## INVITATION TO BID ADDENDUM TO THE ITB

**Project Name: FROB Building Renovations**  
**Project Number: 2013-0222-1851**

| <b>ADDENDUM #:</b> 1                          |                      |

| <b>DATE ADDENDUM ISSUED:</b> May 10, 2013 |

SKA-1

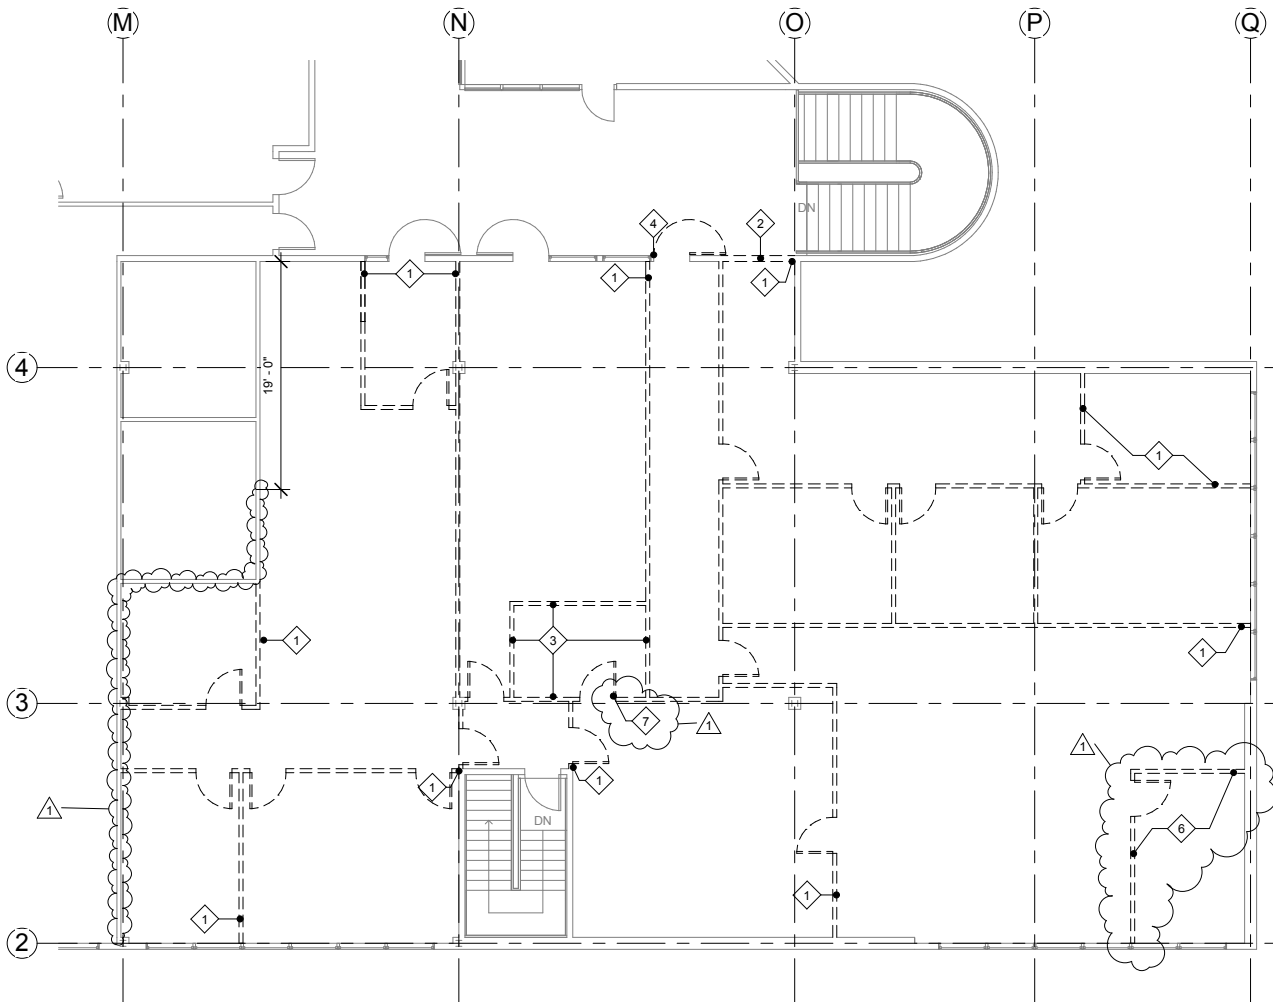
| The 2 Demountable walls encompassing office in SE corner of the worksite is to be salvaged and turned over to SOA, to include track, wall panels, relites, door and door frame. This is new generation wall system and is used throughout the 2nd fl. All other Demountable wall system in the work area is old vintage and can be discarded. See attached revised drawing SKA-1 |   |
| See attached drawings SKA-1 and SKA-2 – The work in this area has been changed   |   |
| Demolition Keynote 1 should read "existing grid and demountable partition track may need additional support. Provide adequate support as necessary."   |   |
| A9.0 Demolition notes; Delete reference to retaining ceiling tile marked for removal. Do not retain any doors except as specifically noted.  |   |

| Project number 11-0013.24           | <b>SKA-2</b> |

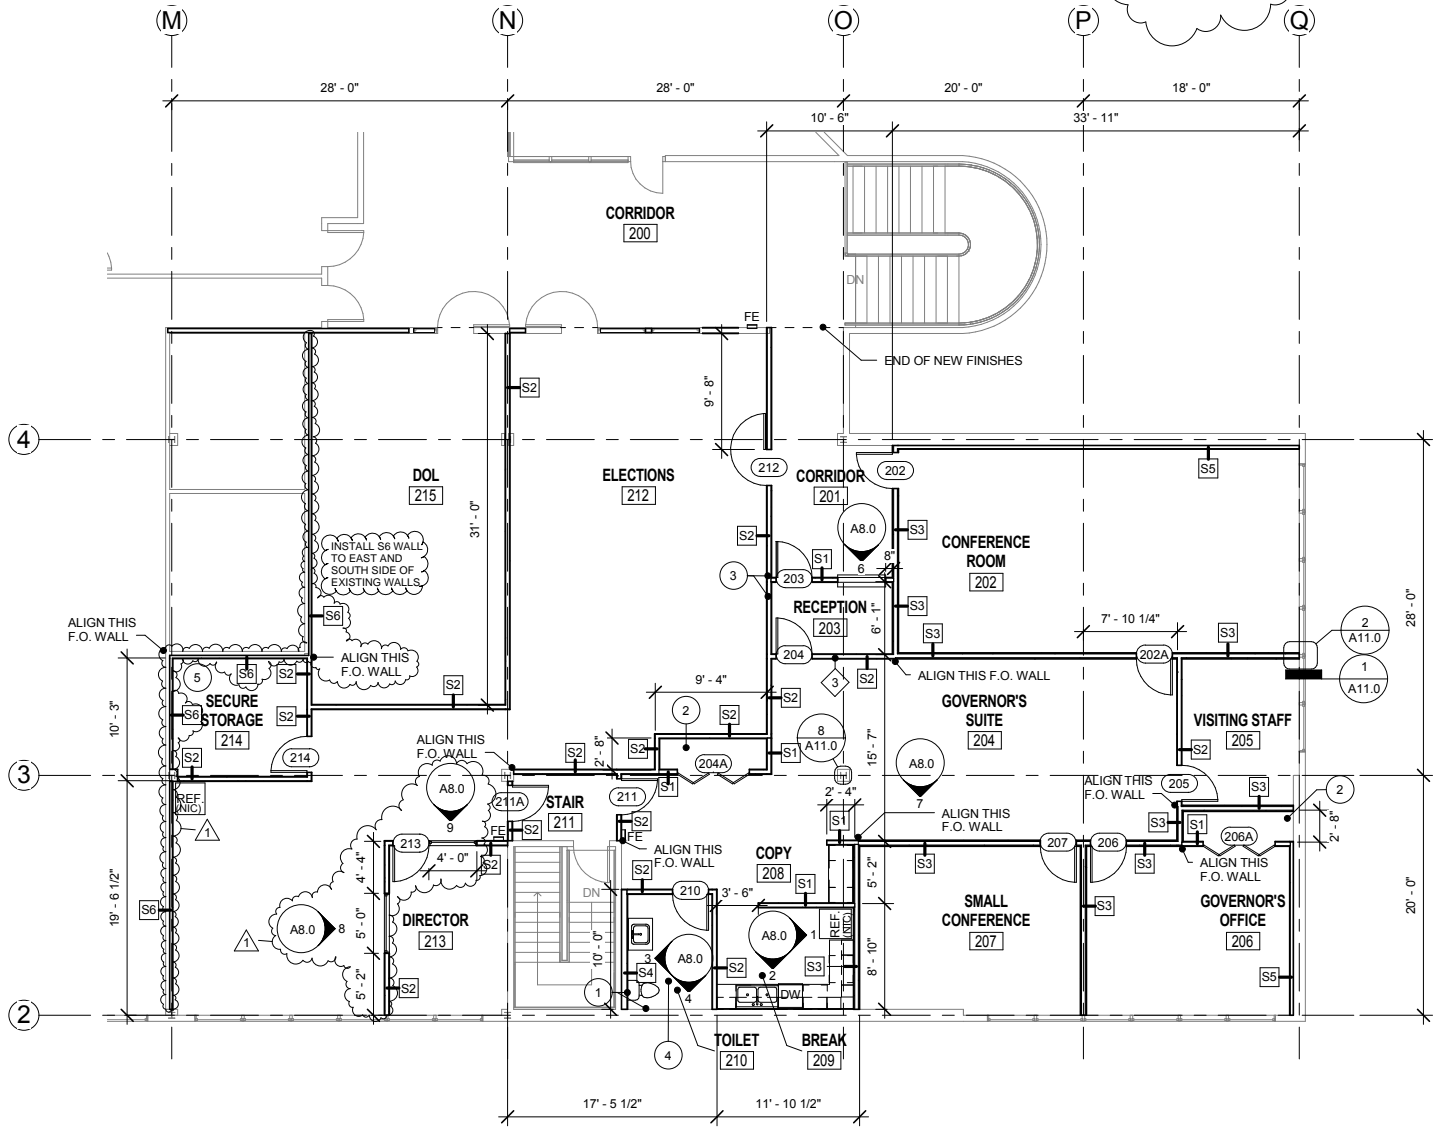
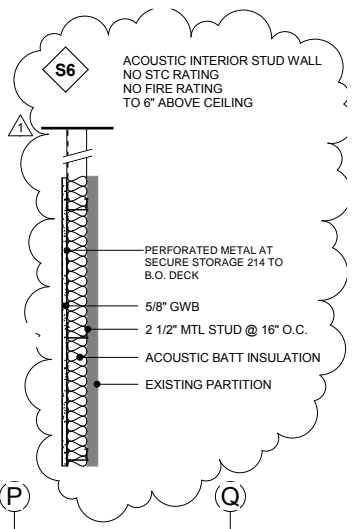
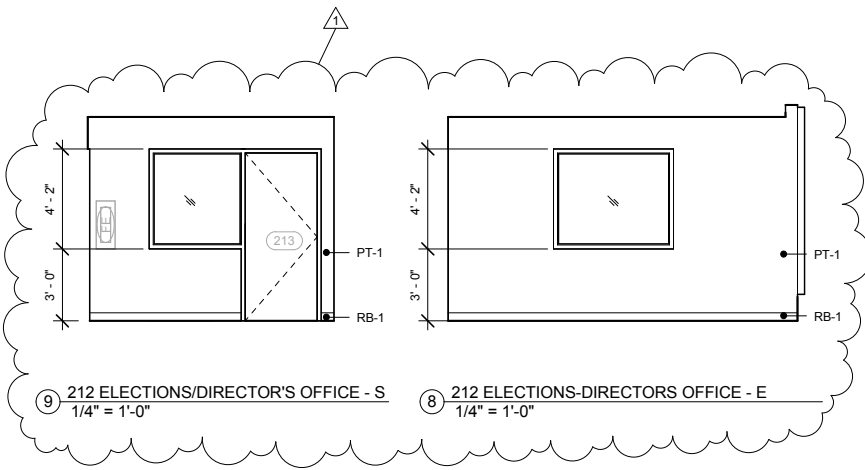
| Answer: See attached drawings SKA-1 and SKA-2 – The work in this area has been changed   |   |

TITLE: SCHEDULES  
 FILE NAME:  
 AUTHOR: CD  
 REVISIONS: 1  
 05.09.2013  
 CHECKED: JS

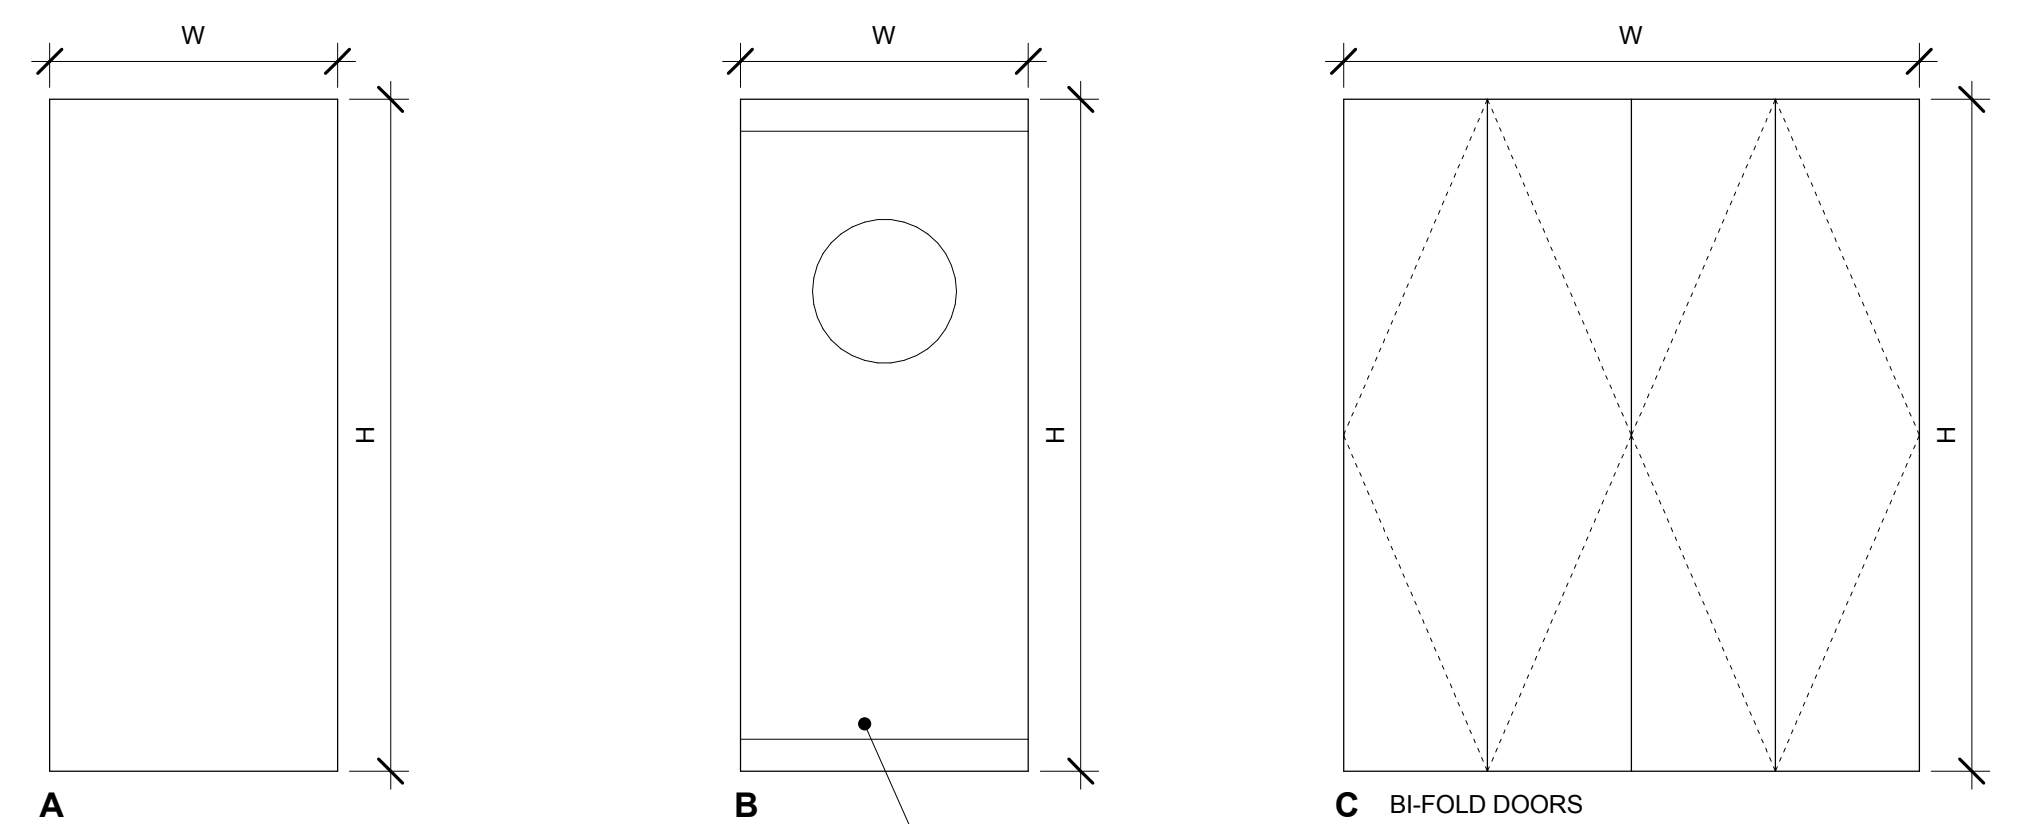
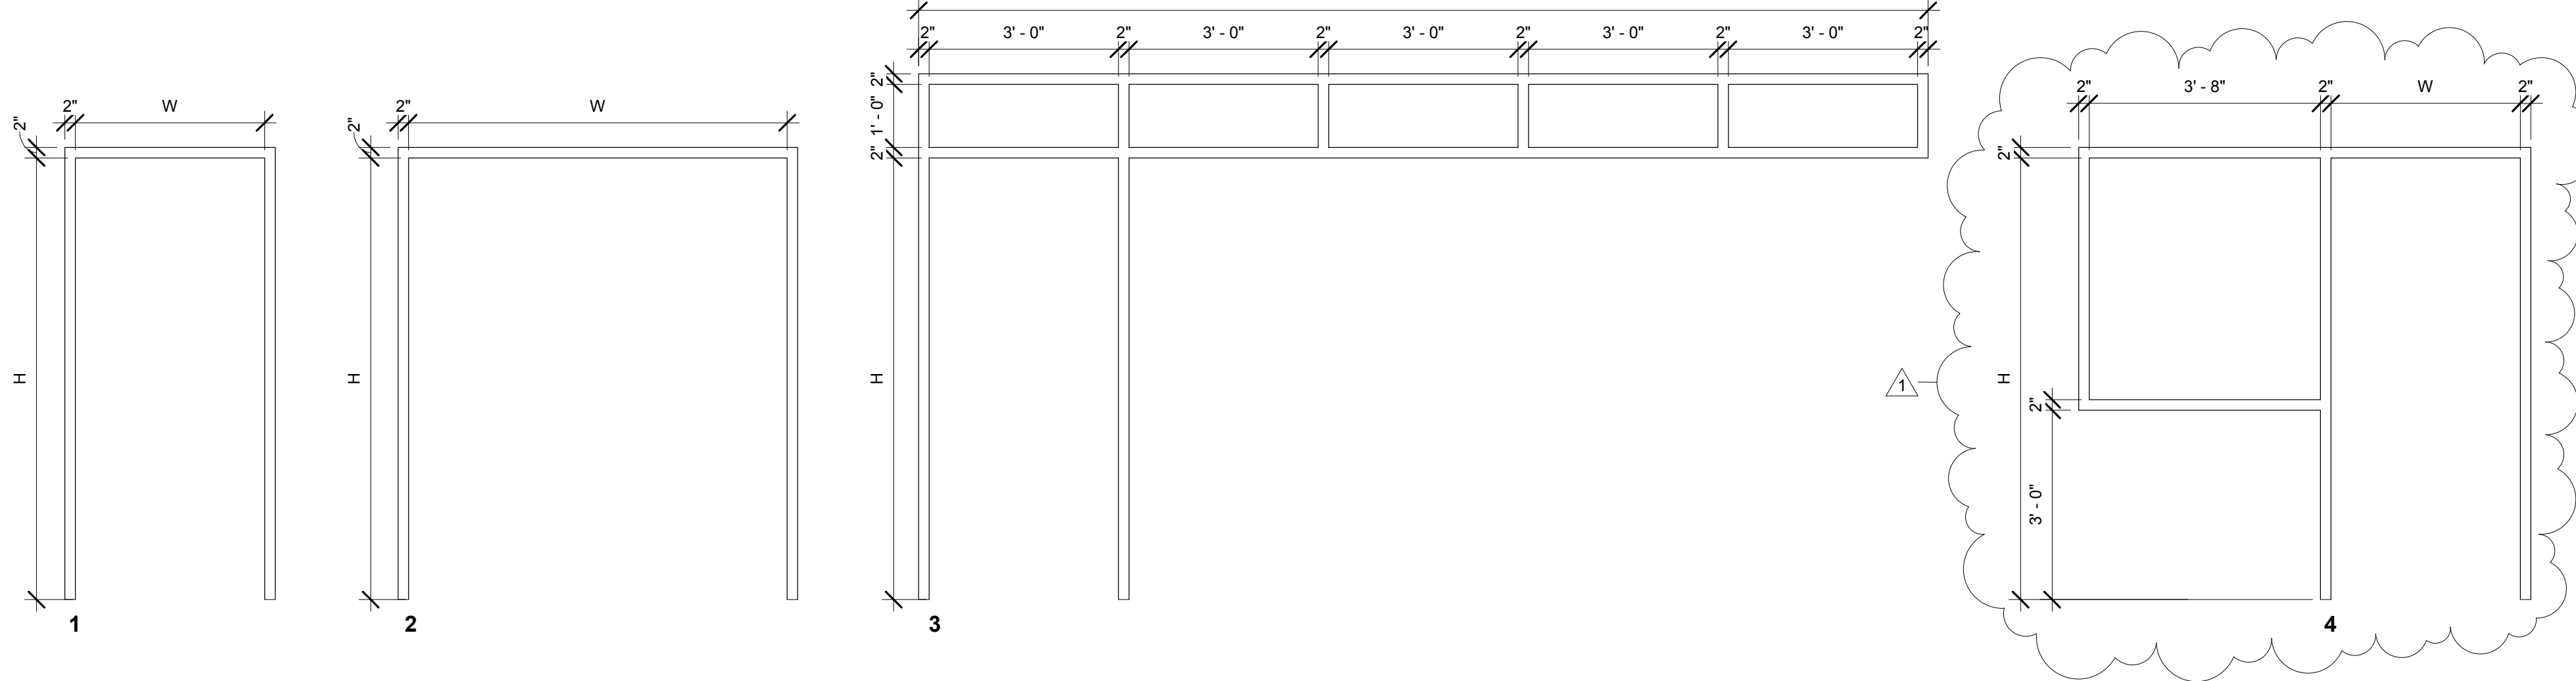
| Door Lock Hardware will be removed, labeled and stored by the SOA. Contractor to co-ordinate with SOA for reuse/installation by the Contractor. Door Hardware Schedule has been revised see attached revised drawing A12.0   |   |

| Answer: Door Schedule has been updated see Attachment # 3 A12.0  |   |

| E2.3                      |       |

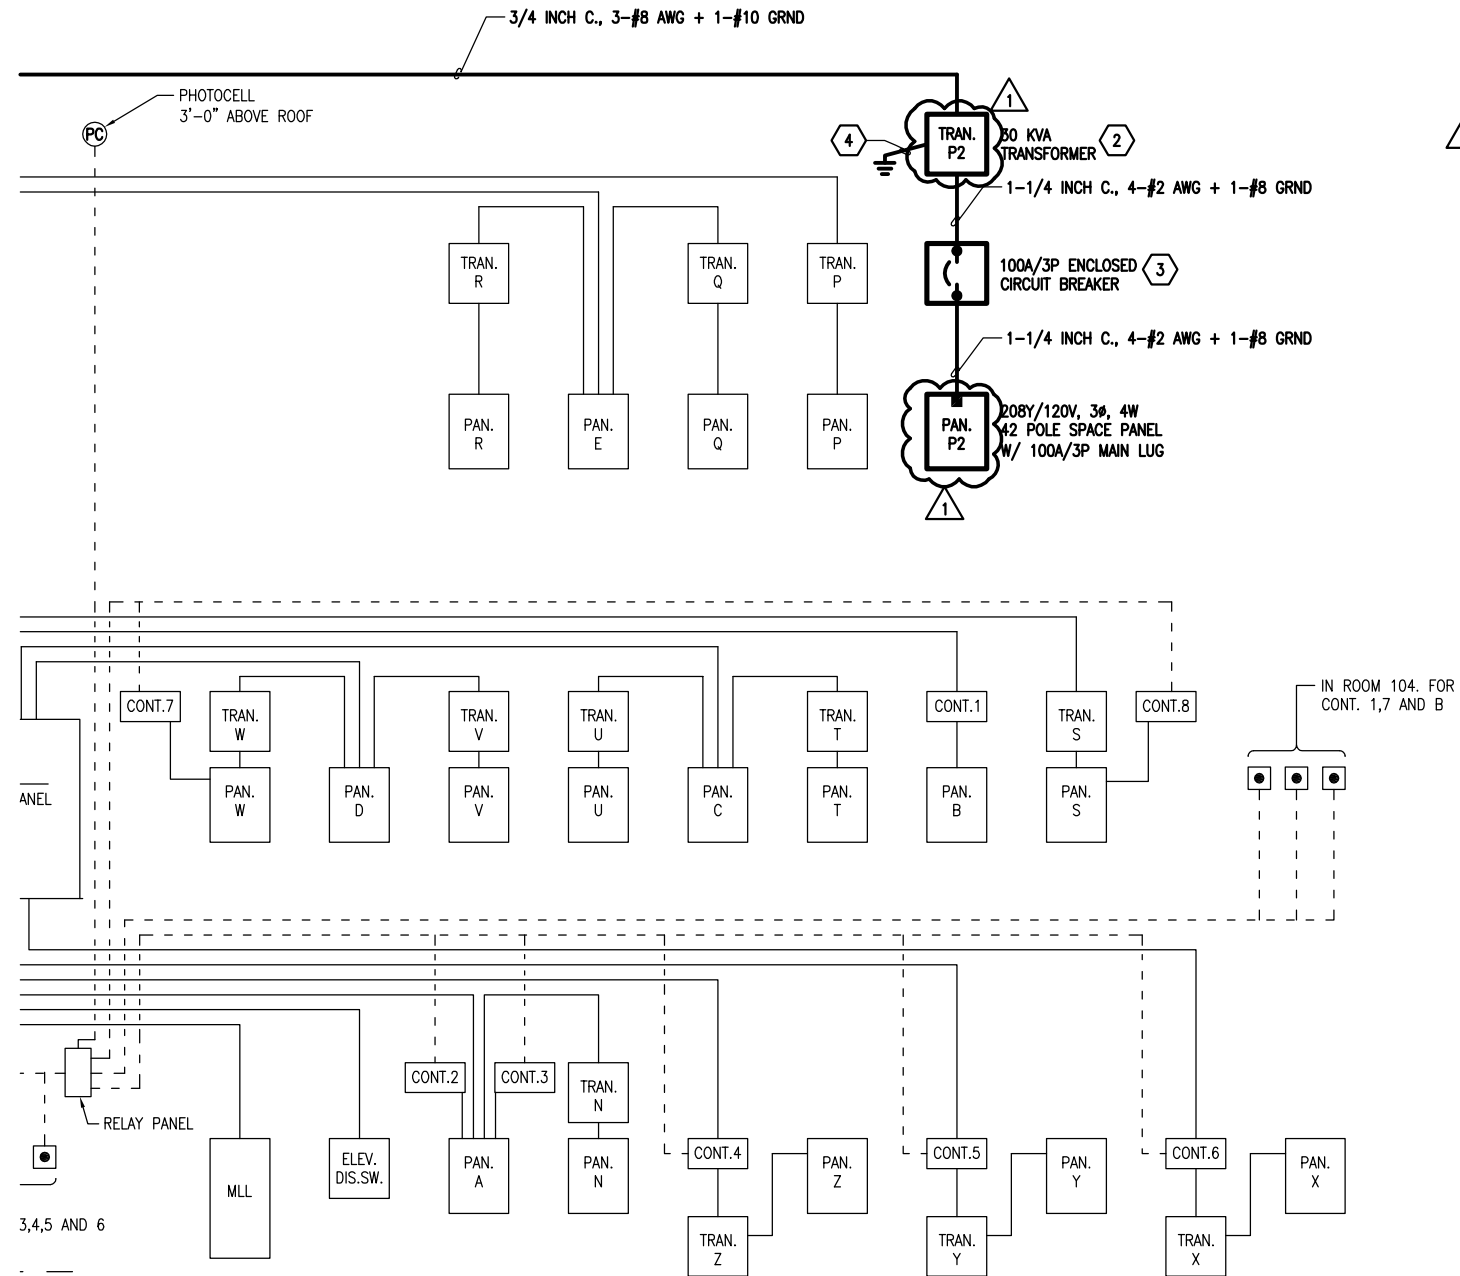
| <b>Item No.3:</b>  | Electrical Specialty Items – see Drawings E1.2 Note 6 and Drawing E2.3 Note 4 & 5                             |
| All work, including demolition and reinstallation, of the Card Access system and CCTV Cameras will be performed by Alcantel, Inc. under the SOA Electrical Services Contract. Rough-ins are to be performed by Contractor as noted.  |   |
